**CITY OF BATON ROUGE  
PARISH OF EAST BATON ROUGE  
DEPARTMENT OF ENVIRONMENTAL SERVICES**

**ADDENDUM NO. 2**

SUBJECT: **PS 299 REGIONAL PUMP STATION**

**CITY-PARISH PROJECT NO. 20-PS-IF-0109**

HORIZ SCALE: 1"=50'  
VERT SCALE: 1"=5'

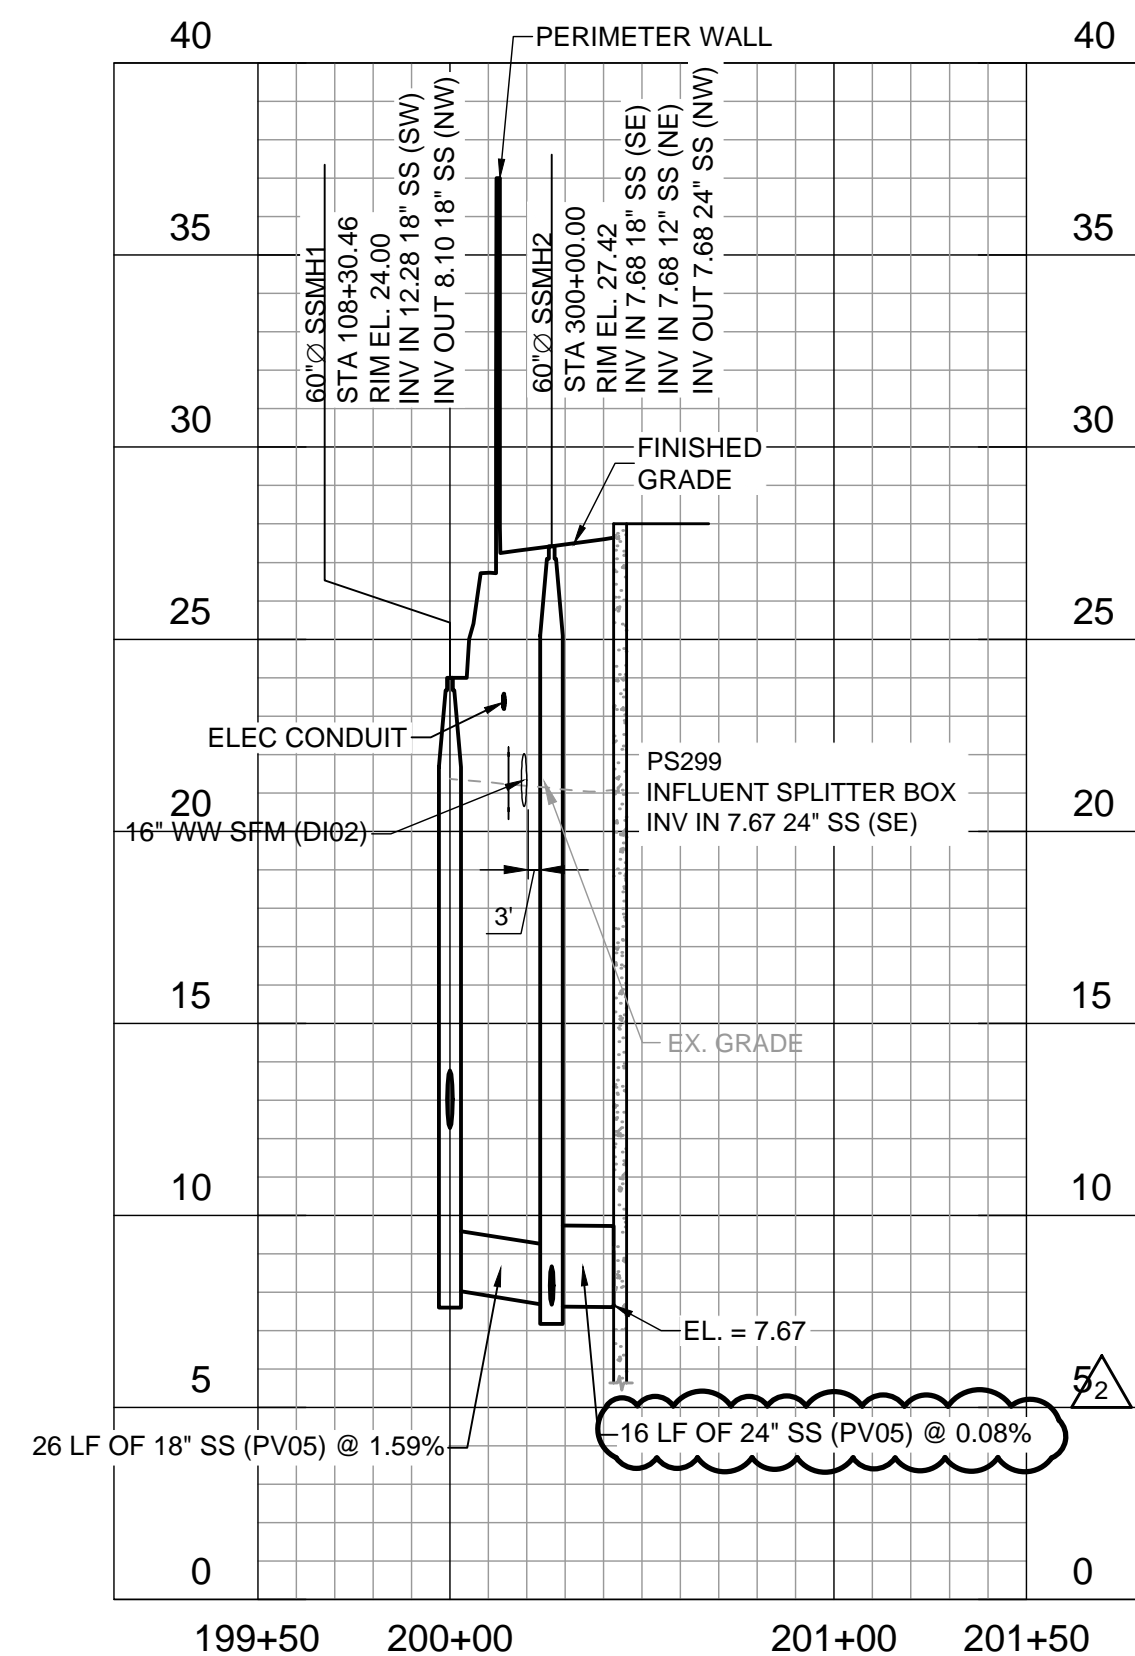
1. For paper sealed bidders, with reference to page UCBF 1 of 4 of Part 1, Uniform Construction Bid Forms, the Bidder shall indicate the receipt of this addendum in the space provided. For online Central Bidding bidders, an acknowledgement of this addendum will be prompted by the electronic bidding program prior to formally submitting the bid. **Failure to indicate the receipt of this addendum shall be cause for the bid to be rejected.**
2. DELETE Drawing C-18R and REPLACE with attached Drawing C-18R Civil Sewer Plan and Profile - I.
3. DELETE Drawing C-19R and REPLACE with attached Drawing C-19R Civil Sewer Plan and Profile - II.

1. The drawings in the addendum state all manholes shall include 1' thick walls, bottom slab, and top slabs. I am hearing from precast suppliers that this is only possible for 120" and larger diameter manholes so I do not think 1' thickness will be possible unless they are rectangular structures. General wall thickness for 60" manholes is 6" and 7" for 72" manholes.

The Contractor may deviate from the specified thicknesses, but are required to provide signed structural calculations, including buoyancy calculations as required by the note.
